Service Bulletin

Subject: Pop Noise From Fuel Tank After a Cold Start or EVAP Purge Event (Equinox / Terrain)

Models: 2010 -2014 Chevrolet Equinox
2010-2014 GMC Terrain

(1) Flange location

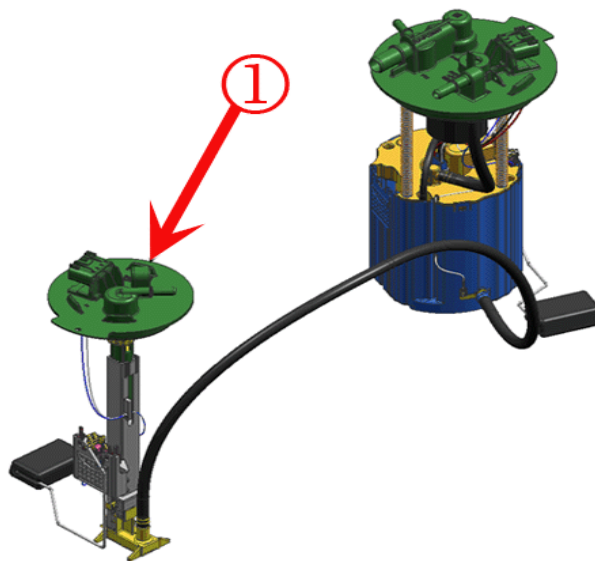
The technician should be able to duplicate the concern by commanding a purge and seal on the EVAP system using GDS2. As the vacuum reaches 3 to 5 inches, the pop/popping noise should be duplicated. The cause for this concern is the auxiliary fuel module in the left side of the fuel tank changing height (spring loaded leg) as the fuel tank collapses slightly.

The part number on the box of the auxiliary fuel module has not changed but the auxiliary fuel module inside of the box has. After ordering the auxiliary fuel module, remove it from the box and verify the letters "PPA" are casted into the top of the fuel module flange. This is the revised auxiliary fuel module designed to correct the pop/popping noise. The original auxiliary fuel module has "POM" casted into the flange.
